AMP Proposal

November 28, 2005

This is a proposed set of changes to APKAS-AMP designed to prevent the attack described in [Kw05] in which an enemy can masquerade as the Client using v_π . This version is based on the AMP+ protocol of [Kw01], [Kw05], and subsequent P1363 Working Group discussions.

Figure 9.5.2—APKAS-AMP key agreement operation

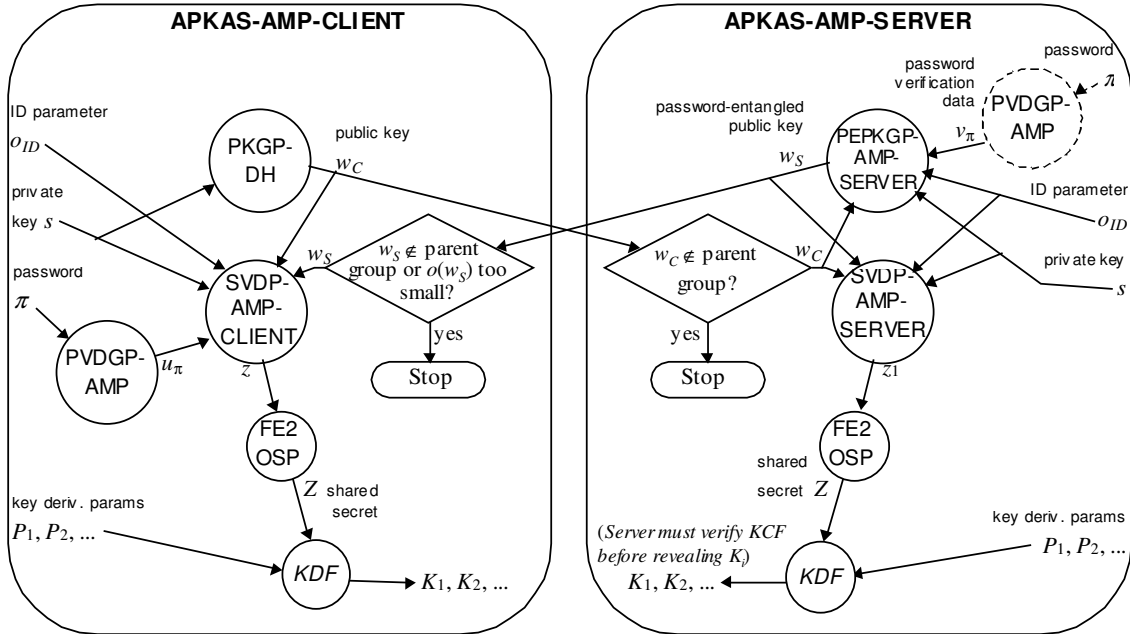
Editor's Note—The D22 APKAS-AMP summary has not yet been updated with the June 2005 proposal.

Editor's Note—See related Editor's notes in the main document regarding validity checks.
